# Some of the Problems With PMA Specifications (Clause 55, 802.3an Draft 1.2)

**Bijit Halder**

**26 January 2005**

IEEE 802.3an: 10BASE-T Task Force

# Fixed THP: Golden

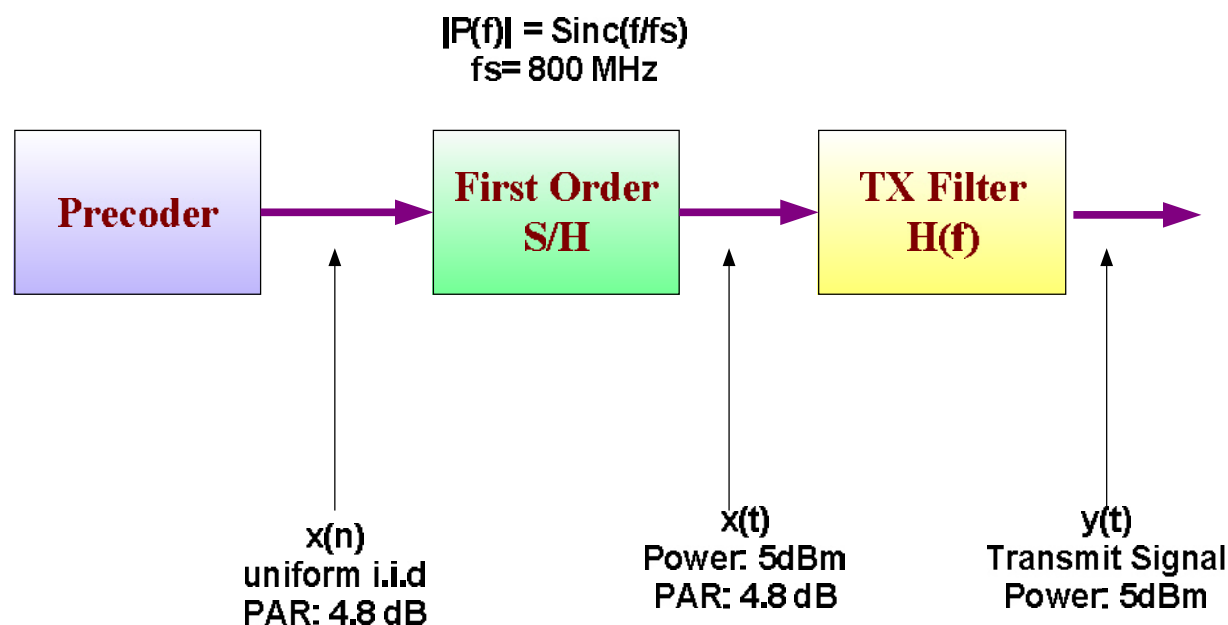
- Conclusions were based on Model 3
- 55m CAT6 cable
  - Suggested power back off for 65m is 5dB
  - Achievable SNR for 55m CAT6 is 23.9 dB
  - Suggested power back off for 35m is 7.5 dB
  - Achievable SNR for 55m CAT6 is 21.5 dB
- The fixed THP and power back off do not work for 55m of CAT6

# Examples of Transmit PSD

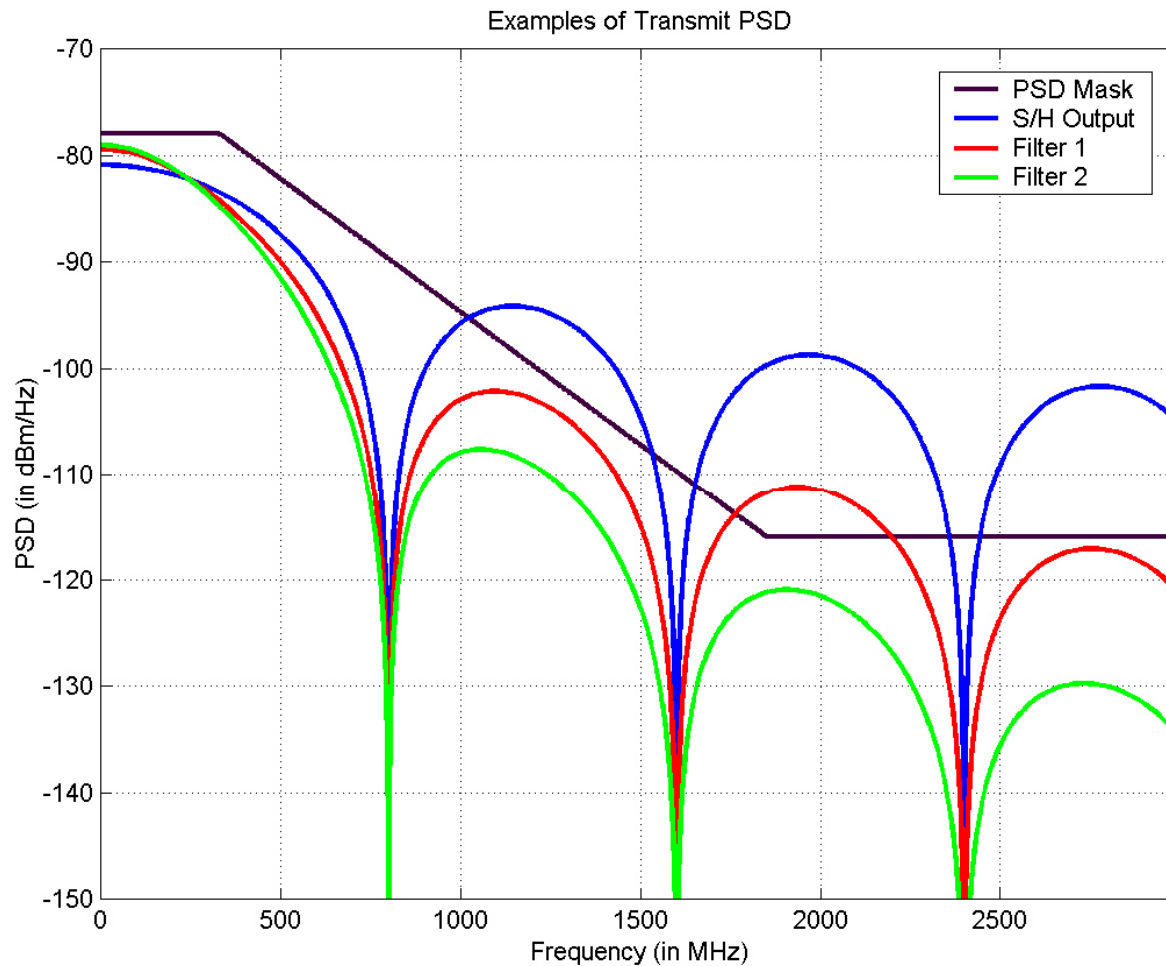
- Filter 1: First order filter with  $f_c=400\text{MHz}$ 
  - 6.35 dB PAR is lower than the limit 6.9 dB
  - Does not meet the PSD mask
- Filter 2: Second order filter with  $f_c=500\text{MHz}$ 
  - Does meet the PSD mask
  - 6.74 dB PAR; too close to the limit 6.9 dB
  - Would cross the limit if  $f_c$  is lowered to 450MHz
- Problem: Not enough margin for PAR
- We should allow for enough tolerance
